UNITED STATES PATENT AND TRADEMARK OFFICE

| APPLICATION NO. | FILING DATE | FIRST NAMED INVENTOR | ATTORNEY DOCKET NO. | CONFIRMATION NO. |
|--|-------------|----------------------|----------------------|------------------|
| 10/712,498 | 11/12/2003 | Fuk Chai Alvin Wai | MAT 316 | 8944 |

| Office Action Summary | Application No. | Applicant(s) | |

DETAILED ACTION***Claim Rejections - 35 USC § 102***

**FIG 1****FIG 2**

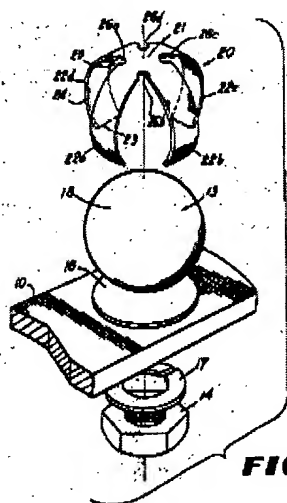
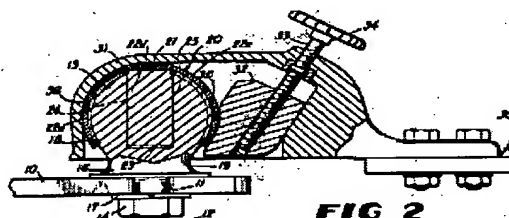
Claims 1, 4, 5, 7-21, and 23-26 are rejected under 35 U.S.C. 102(b) as being anticipated by Suarez.

Suarez discloses a movable toy comprising a first body part member (10); and a second body part member (31), a joint is defined between the first and second body part members (10,31) to enable relative motion between the first and second body part members (the first and second body parts are enabled by the socket (20) and plug (ball) (13)), the joint comprises a plug portion (13) secured to one of the first and second body part members (10,31); and a socket portion (20) secured to the other of the first and second body part members (10,31) and adapted to receive the plug portion (18), the

socket portion (20) includes multiple spaced apart protrusions (22a,22b,22c,22d), the joint being adapted so that an operative surface (the outer surface portion of reference numeral 13) of the plug portion (13) is urged into contact with ends of the protrusions (22a,22b,22c,22d) so as to create friction therebetween (*the fingers snugly grasp the body 18, col. 2, line 63-66*); and a separately manufactured removable insert (14) adapted to secure the plug portion (13) within the socket portion (20); the protrusions are formed as ribs that extend toward the operative surface of the plug portion (13) that extend toward the operative surface of the plug portion from a wall of the socket portion (18); each of the multiple contact regions are formed at an end of a protrusion that extends toward the operative surface of the plug portion (13); the protrusions (ribs) extend toward the operative surface of the plug portion at angles to one another; the operative surface of the plug portion is convex (col. 2, lines 36-39) and at least one of the multiple distinct contact regions is concave (col. 2, lines 36-39); the socket portion (20) is configured to capture and hold a head (18) of the plug portion (13) within the socket portion (20) (col. 2, lines 63-66); the socket portion (20) is adapted to urge the head (18) of the plug portion (13) against the multiple distinct contact regions (22a,22b,22c,22d); the plug portion (13) includes a head (18) and a shaft (12) extending therefrom, the shaft (19) being narrower in width than the head (18); the shaft (12) extends from the head (18) through an opening (the female threaded portion of reference numeral 14); the opening (the female threaded portion of reference numeral 14) is sized smaller than the head (see Figure 1, for example); the shaft (12) extends away from the head (18) between the first and second body part members (10,31)..
